RED BARN MACHINE			
TITLE MAIN XSMN SPANNER			
DWG NO. RBT400222			REV 3
UNLESS OTHERWISE SPECIFIED DIMENSIONS ARE IN INCHES			
TOLERANCES ON:			
DECIMALS .XXX ± .005 FRACTIONS ± 1/32 ANGLES ± 5°			
UNLESS OTHERWISE SPECIFIED 1. BREAK ALL SHARP EDGES .015 x 45° PR .015 R 2. DIMENSIONAL LIMITS APPLY AFTER PLATING			
SCALE NTS DATE 10-23-01 SHEET 1 of 1

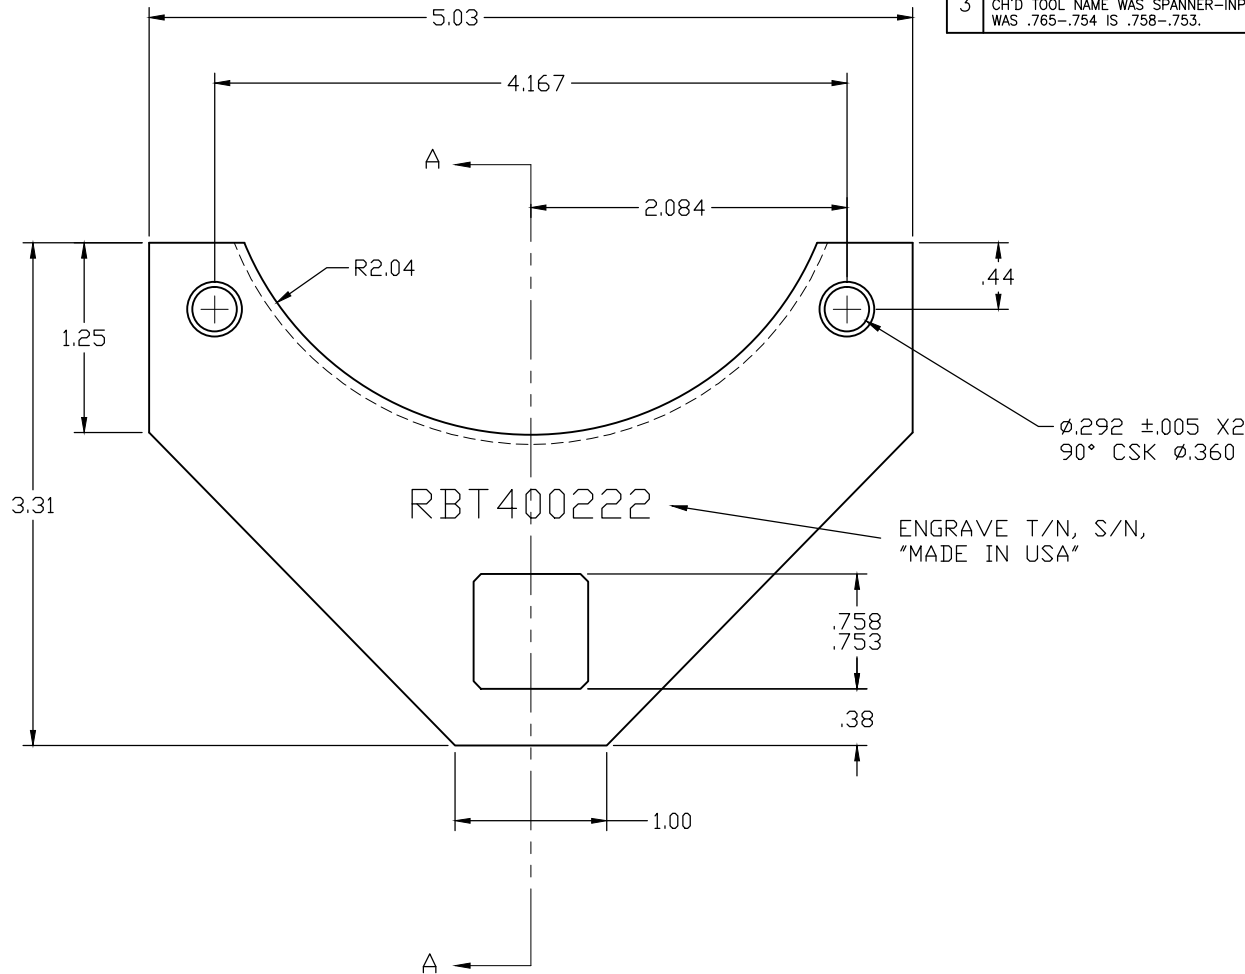
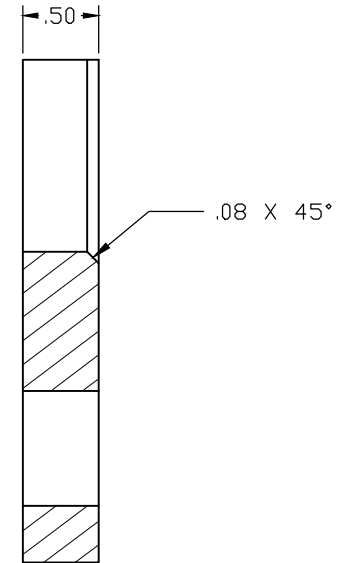
REVISIONS				
REV	DESCRIPTION	DATE	INITIAL	APPROVED
1	FINISH CHANGED TO PHOSPHATE, MATERIAL CHANGED TO 4140.	5-14-03		
1A	CH'D REVISION TO NUMERICAL, LABELED SECTION VIEW, CH'D TITLEBLOCK & REVISION BLOCK, CH'D DWG. NO. FROM 407-240-010-101.	6/22/09	RJC	RW
2	CH'D FINISH FROM PHOSPHATE PER E.B.	12/1/11	RJC	EB
2A	DELETED DIA. SYMBOL FROM CHAMFER .075 X 45° & CH'D DIM. PRECISION FROM .XXX TO .XX ON NON-CRITICAL PARTS.	9/3/13	CFS	GE
3	CH'D TOOL NAME WAS SPANNER-INPUT ADAPTER IS MAIN XSMN SPANNER. CH'D SQUARE DRIVE WAS .765-.754 IS .758-.753.	12/18/13	RJC
